September 20, 2023

Mr. Ardeshir Sharifabadi  
Project Manager  
APP Unit, Groundwater Protection Value Stream  
Water Quality Division  
Arizona Department of Environmental Quality  
1110 W. Washington Street  
Phoenix, Arizona 85007

RE: Copper World Project – Aquifer Protection Permit Application – Response to “Inadequate Response to a Comprehensive Request for Additional Information” Letter dated June 23, 2023

**Illustration 16-1 Tailings Storage Facilities Filling Curve**

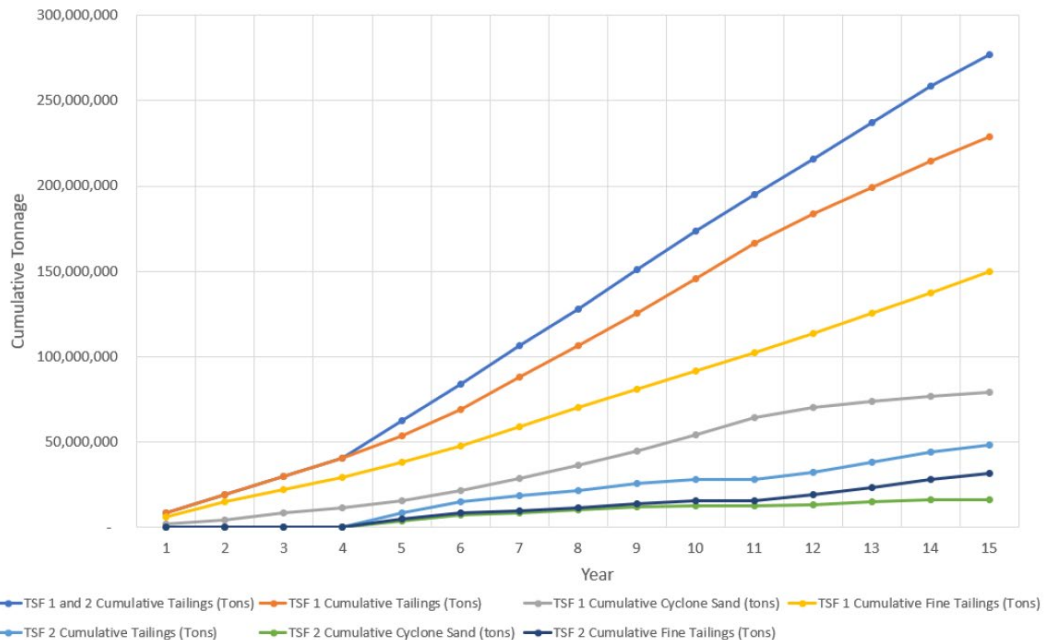
- c. Please provide an annual mass balance for the TSF, which should include Cyclone sand, Fine tailings, and compacted berm materials. Additionally, please provide a filling curve to depict the progression of filling activities over time.

*Response: The estimated tonnage of tailings and heap ore placed in the TSFs and HLF, respectively, are provided on an annual basis on the progression figures in Attachment 6. An annual filling curve for the two TSFs is also presented in Illustration 16-1 below. The illustration presents the cumulative fine tailings going into the impoundments and the cumulative cyclone sand tailings used to construct the TSF embankments. Also see Table 16-1 for these materials quantities.*

**Illustration 16-2 Typical TSF Cross Section Showing Piezometer Locations**

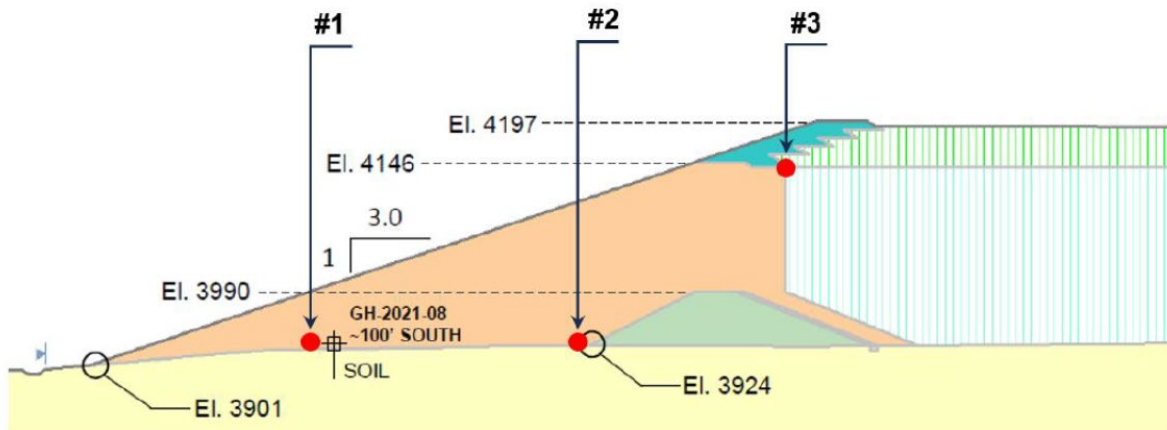
- d. The proposed monitoring instruments are required to be assigned an alert level that corresponds to quantifiable performance objectives. This ensures their effectiveness in monitoring objectives, consistency with the design assumptions, and detecting adverse conditions at an early stage. Provide the typical alert levels for the monitoring instruments in the TSFs. This may include but not be limited to vibrating wire piezometers, slope indicator, standpipe, prisms, InSAR etc.

*Response: The design of the TSFs includes two sets of three piezometers for each of the five TSF cells. The three piezometers for each set will be installed at the locations where stability is critical, as shown in **Illustration 16-2**. The first two piezometers (denoted #1 and #2 in **Illustration 16-2**) will be installed in the downstream cyclone dam embankment prior to the deposition of cyclone sands. The third piezometer will be installed near the dam crest once the TSFs begin the upstream embankment construction. A low and high trigger level has been developed for each set of piezometers with the first two being 20 and 40 ft of head, respectively. The third one has a lower trigger level of 10 and 20 ft of head for the low and high trigger levels, respectively. Piezometers will be read monthly or on an as-needed basis. Piezometer locations are shown on the annual progression plans in **Attachment 6**.*
